SOUTH ELEVATION - ALONG HYDRAULIC ROAD

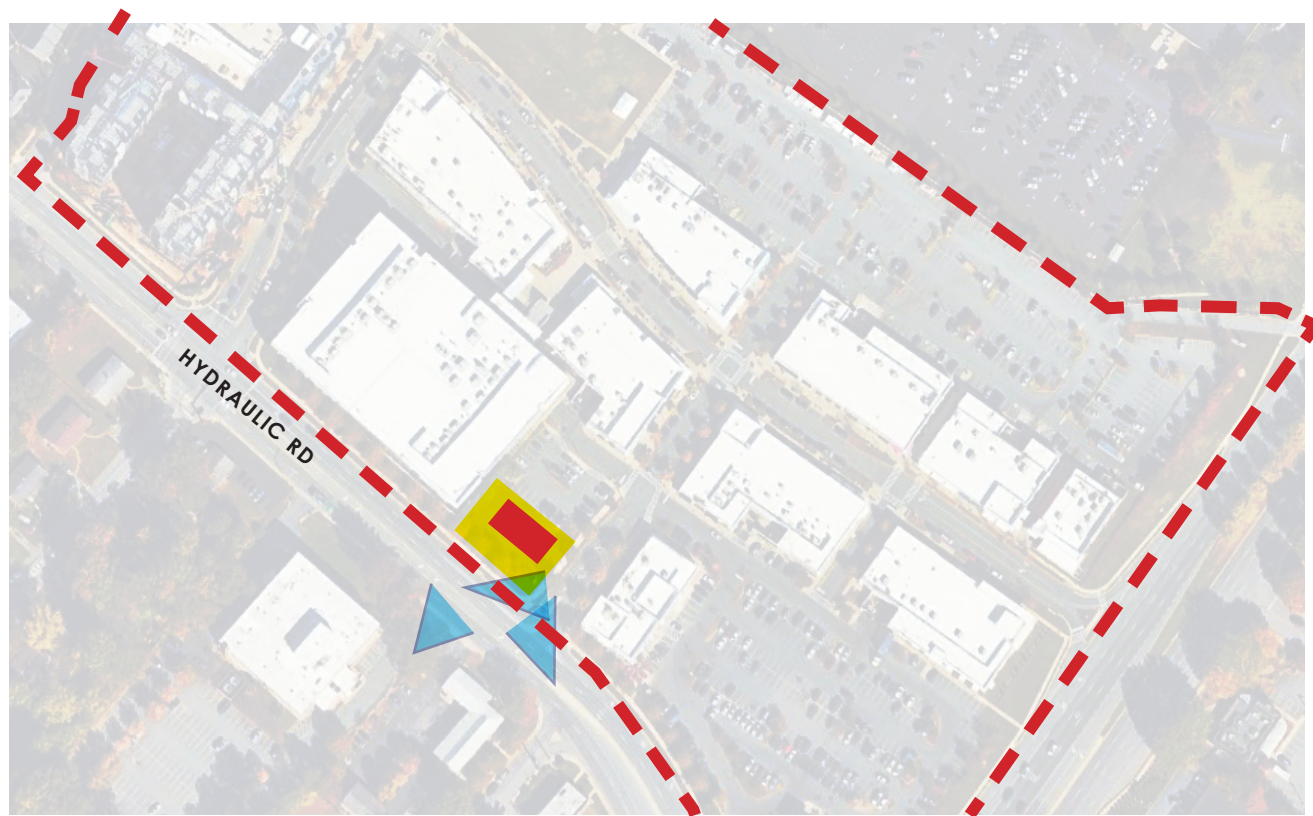
1. Revise the design of the south elevation to present as appropriate appearance for the Entrance Corridor, to eliminate the back of building character, and to coordinate better with similar sized buildings in the shopping center. Revisions to the location and treatment of bays, the position of window/door openings within bays, the relation between the roof screen and the bays, and the detailing of the bays are recommended. Revise the side elevations to maintain coordination.

- Bays of Hardie siding were added to reduce the scale of the rear facade. Proposed additional signage would also enhance the rear to minimize the back-of-building feel.

EAST ELEVATION - ALONG SWANSON DRIVE

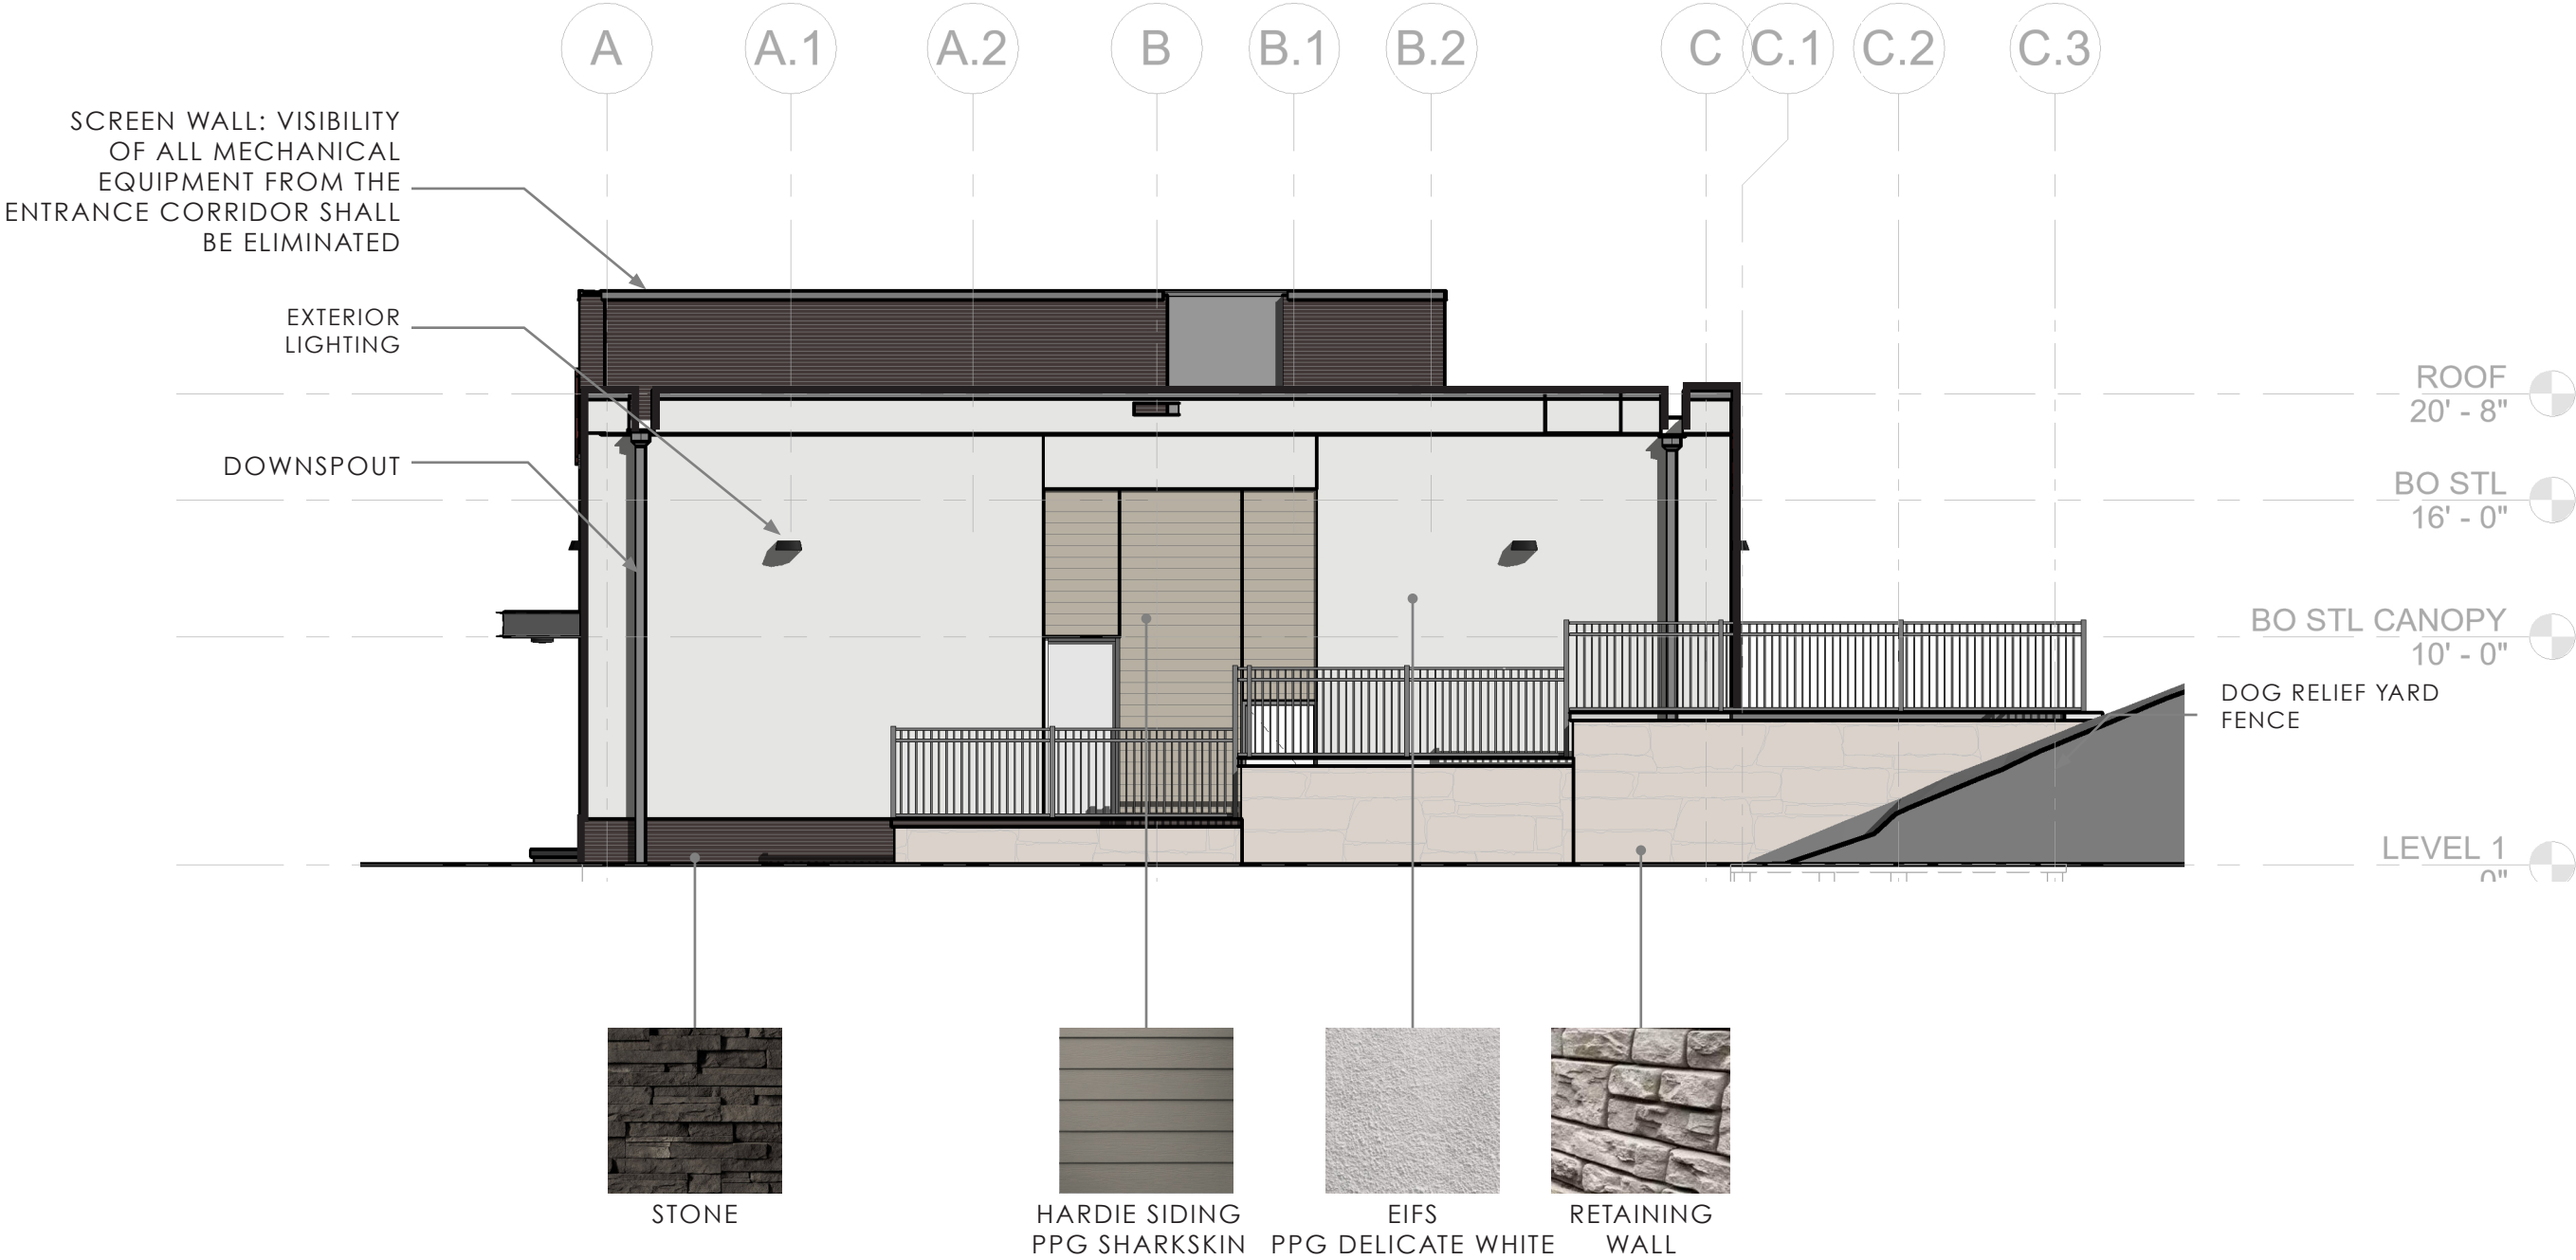
1. Revise the design of the south elevation to present as appropriate appearance for the Entrance Corridor, to eliminate the back of building character, and to coordinate better with similar sized buildings in the shopping center. Revisions to the location and treatment of bays, the position of window/door openings within bays, the relation between the roof screen and the bays, and the detailing of the bays are recommended. Revise the side elevations to maintain coordination.

- The proposed side facade facing the EC adds slim bays of Hardie siding with surface mounted green screens, similar to the facade at Trader Joe's.

NORTH ELEVATION

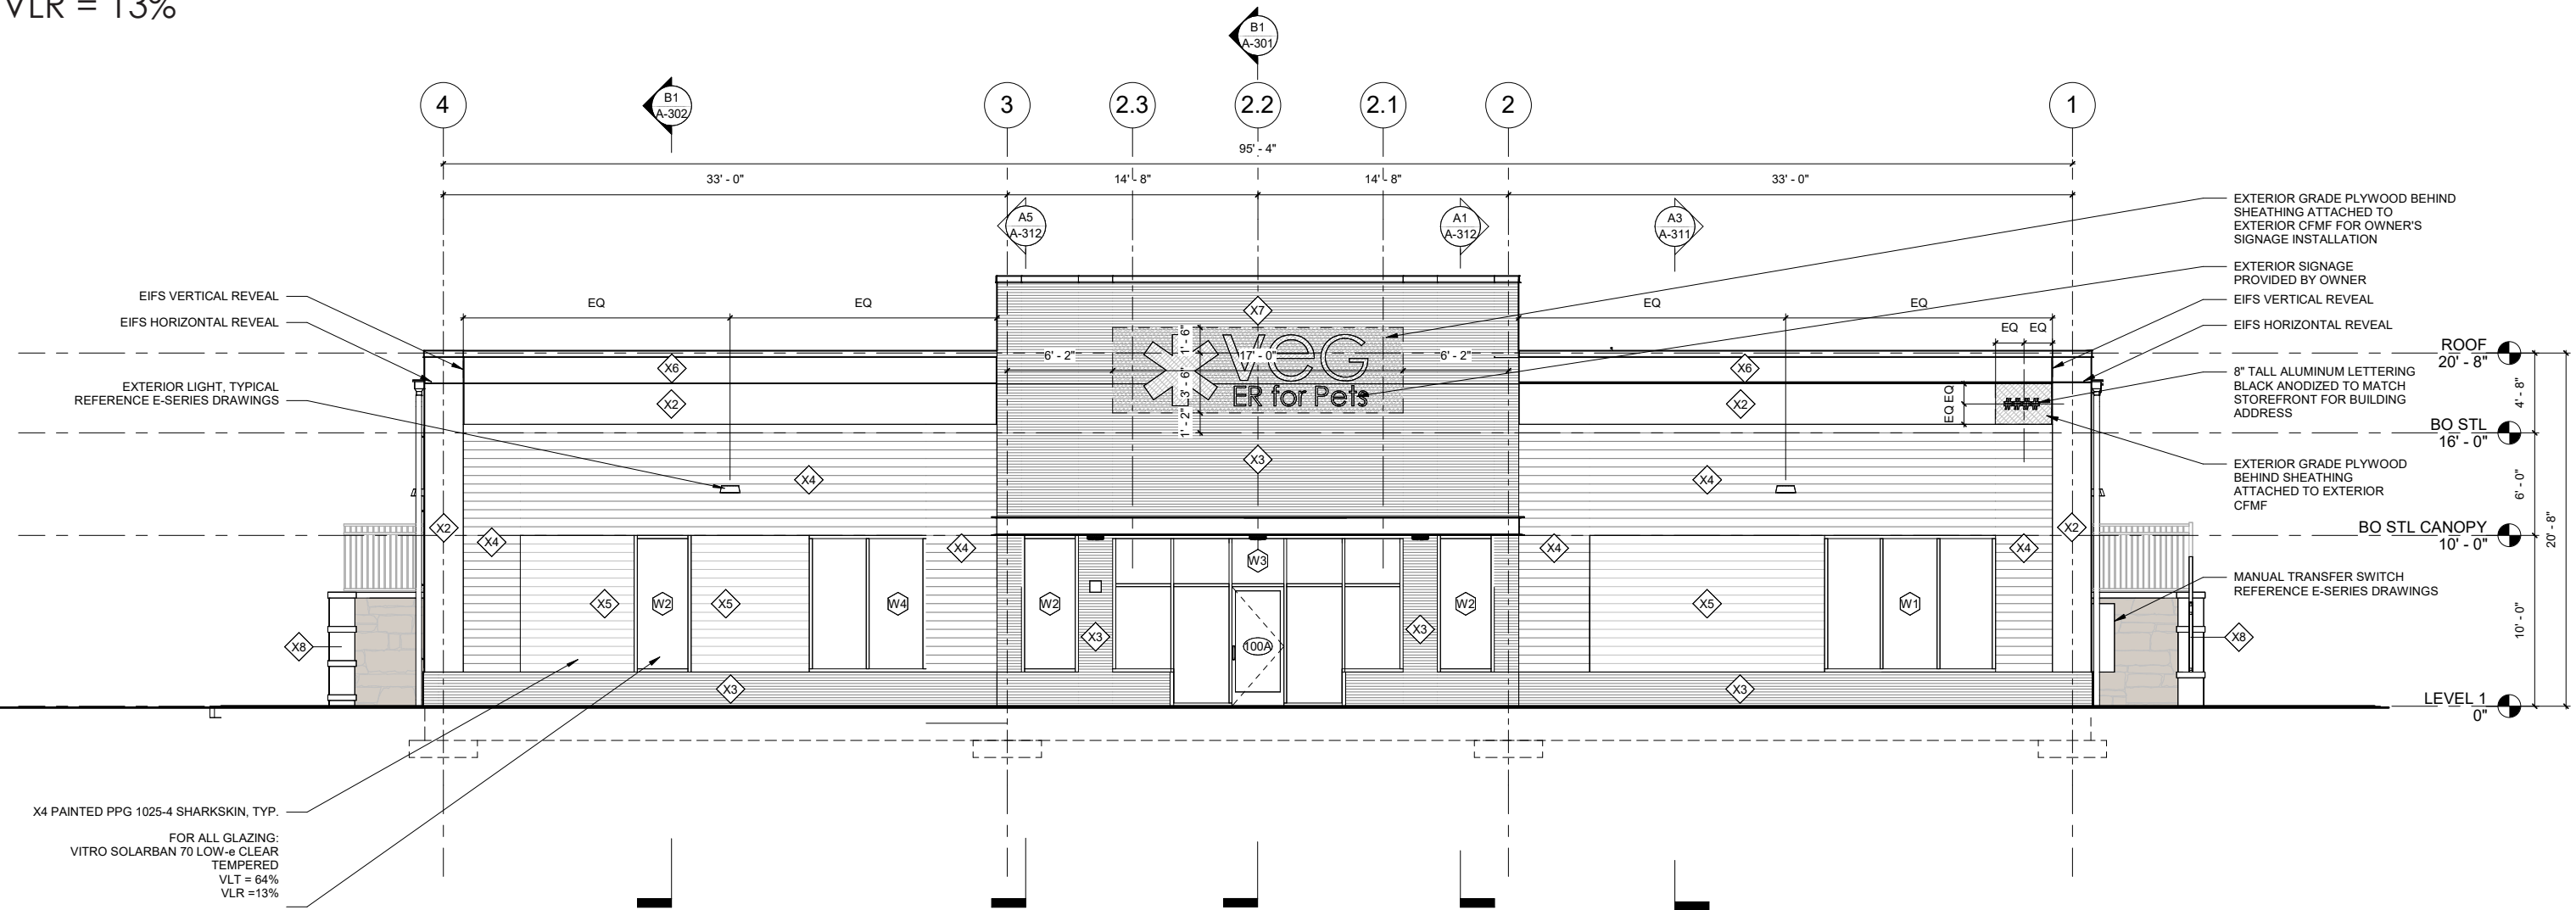
3. Add a note to the plan stating that window glass will meet the criteria: VLT not below 40% and VLR not above 30%

- The follow note has been added to the elevations in the construction documents:

FOR ALL GLAZING:
VITRO SOLARBAN 70 LOW-e CLEAR
TEMPERED
VLT = 64%
VLR = 13%

PROPOSED APPROACH - NORTHBOUND HYDRAULIC ROAD

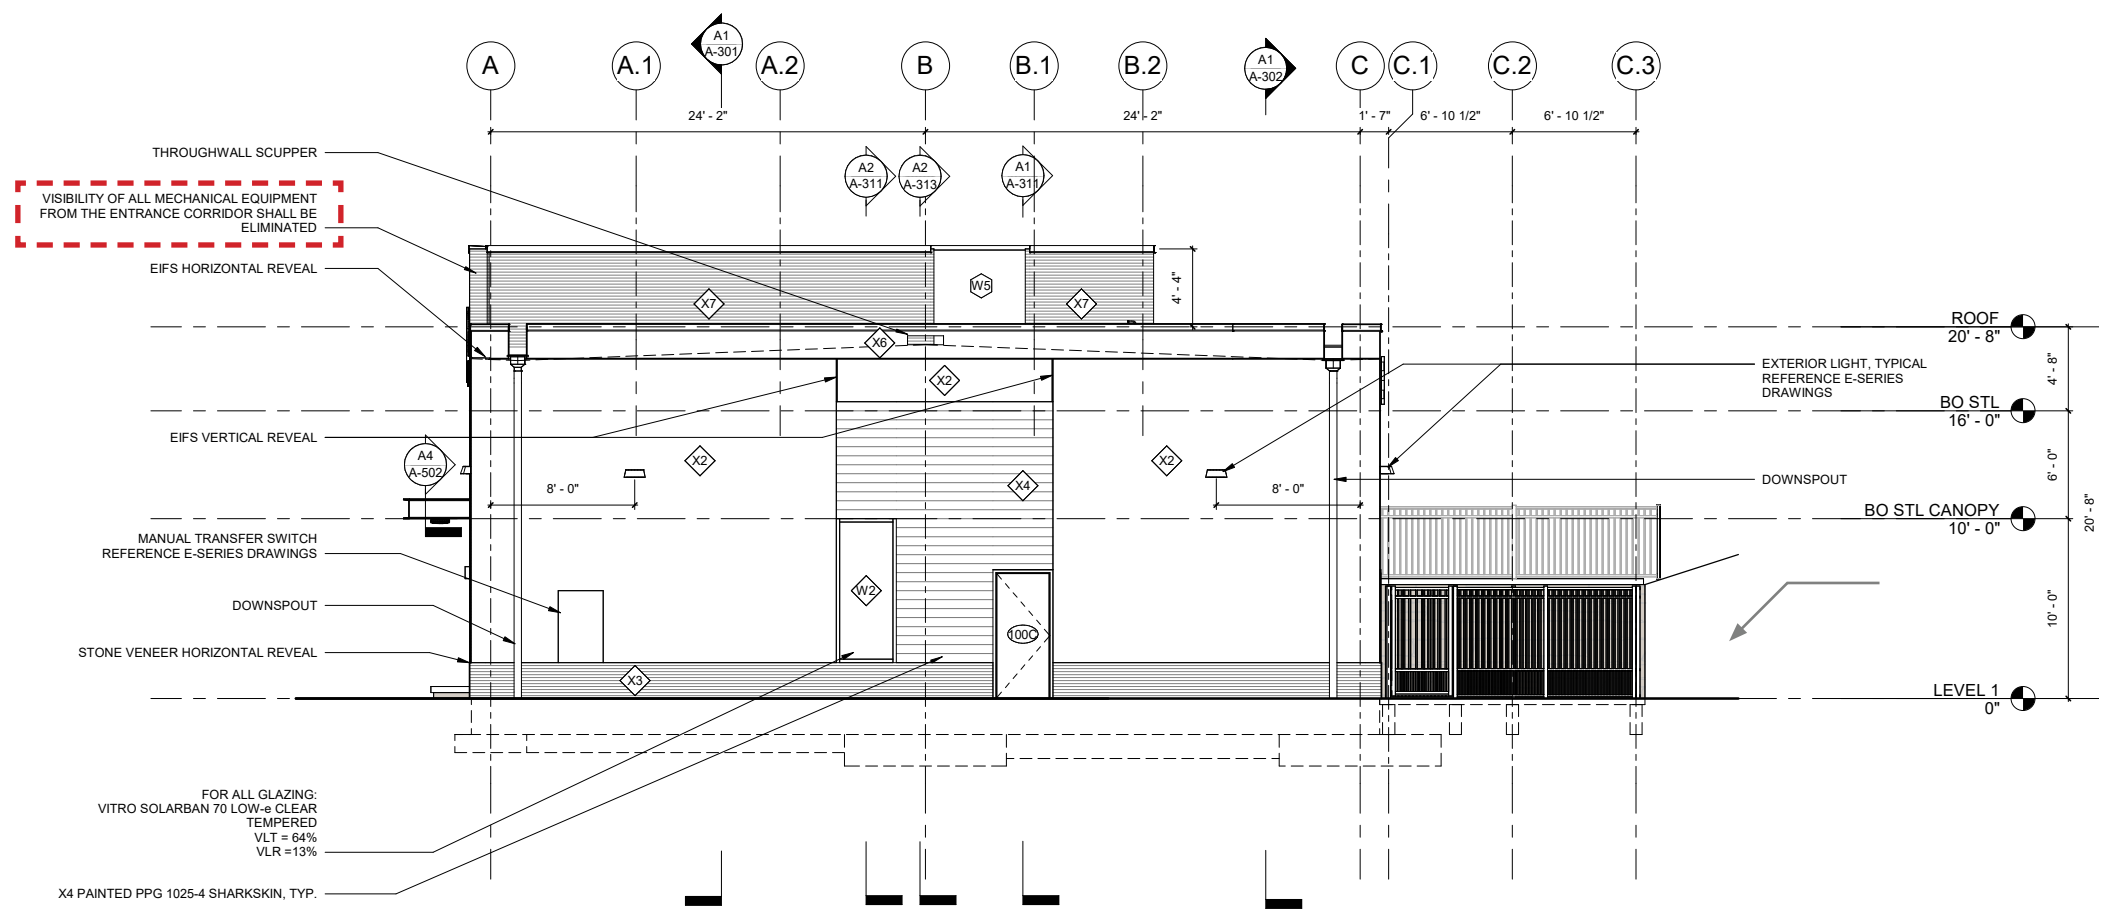
4. Integrate the equipment screening with the overall architectural design as viewed from Hydraulic Road.

Mechanical screens for adjacent buildings do not extend through the building. The proposed screen is discreet and does not overwhelm the presence of the building upon approach on Hydraulic Road.
